Thank you for considering our manuscript, *Optimal Control of Axial Dispersion Tubular Reactors with Recycle: Addressing State-Delay through Transport PDEs*, for publication. We are also grateful to the reviewers for their valuable comments and suggestions, which have been very helpful in improving our work.

Reviewer 1

Figure 1: Concentration profile along the recycle stream

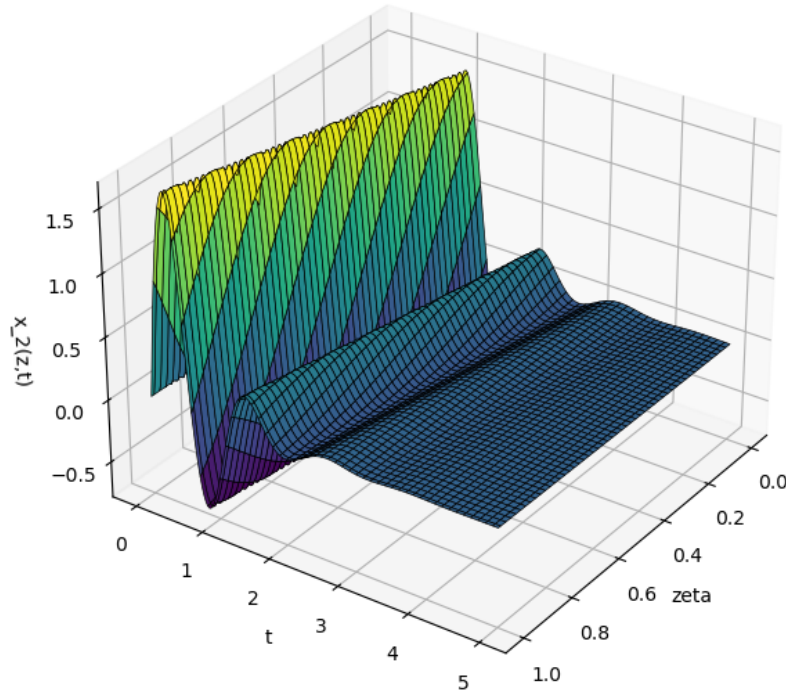
6. Page 7 - " $x_2(\zeta, t)$ is introduced as a new state variable to account for the concentration along the recycle stream"

- Why is x_2 a function of ζ ? How does x_2 change across the recycle? What kind of law does it follow? To me, it seems like x_2 only changes with respect to time

We have assumed that along the recycle stream, the flow of the reactant belongs to the class of pure transport PDEs. This is the case when the diffusion term and the reaction term become negligible compared to the convective term, and the state variable x_2 is merely being transported along the recycle stream. Nevertheless, this still implies that x_2 is a function of ζ and t . Concentration profile along the recycle stream has not been presented in the original submission as we believe it is not the focus of this work. However, for the reviewer's reference, it is included here in the response as shown in Fig. 1.

Figure 2: Axial tubular reactor with recycle stream.

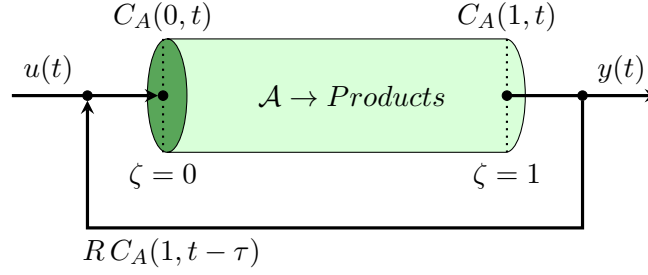
11. Page 18 - unstable dynamics of the model

- Why is the zero-input response considered unstable? Is it a qualitative assessment? What is the physical meaning of Figure 9?

We appreciate the reviewer's thoughtful questions regarding the zero-input response and its interpretation. As mentioned previously, the original submission focused on the broader goals of the study, offering a concise explanation of the proposed model. However, based on the reviewers' feedback, we recognized the need to address potential misunderstandings caused by this brevity. To address this query comprehensively, we aim to clarify the modeling approach by outlining the modeling steps and the reasoning behind the chosen framework here in the reply, as they are critical for understanding the observed instability and its implications. In addition, we have also updated the manuscript to provide a more detailed and general explanation of the model. These revisions ensure that the manuscript presents a clearer and more comprehensive framework while preserving the original model's intent and structure.

For the axial dispersion tubular reactor presented in Fig. 2, the molar balance equation may be written for the reactant concentration, C_A , as follows:

As a result, the zero-input response is considered unstable due to the positive reaction term in the model. Figure 9 illustrates the unstable dynamics of the linearized model in the vicinity of the steady-state in the absence of control input; with the qualitative assessment that a deviation from the steady state may draw the system to a different steady state, resulting in completely different model dynamics than the one used to design and control the system for optimal operation. The manuscript has been updated to include more detailed explanation in this regard.
